## Transmission System Constraints Decrease Generation Reliability

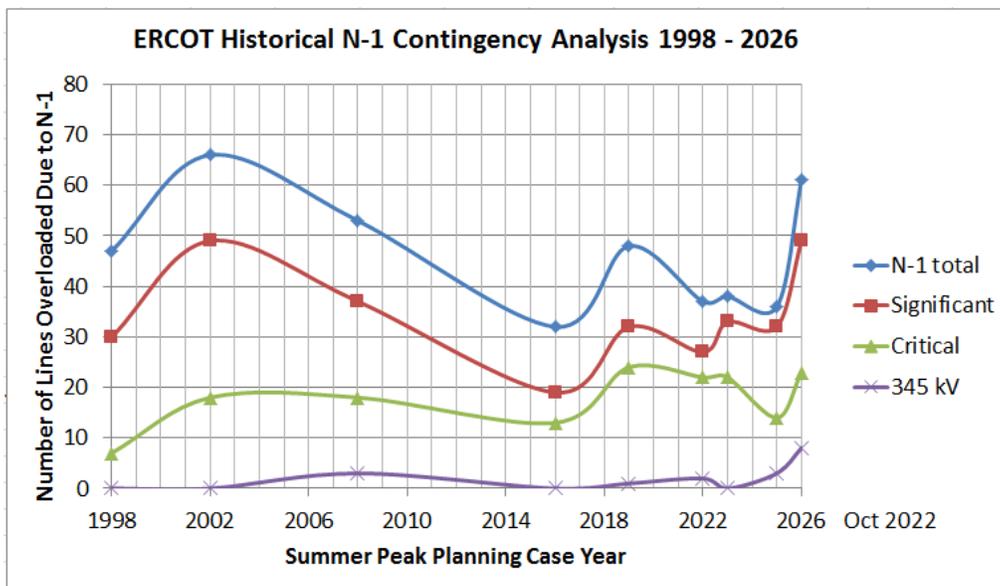
Two strong indicators for the decline in transmission adequacy are: 1) the number of GTCs<sup>1</sup> are rising, and 2) the number of N-1<sup>2</sup> overloads has an upward turn in the 2026 case dated Oct 2022 (see below).

**2) N-1** analysis means testing all single line outages for causing other lines to overload. If lines start tripping out on overload, the worst case scenario is a blackout the entire system. The above graph shows numbers of N-1 line overloads each year. Look for **localized red areas** on the real time map.
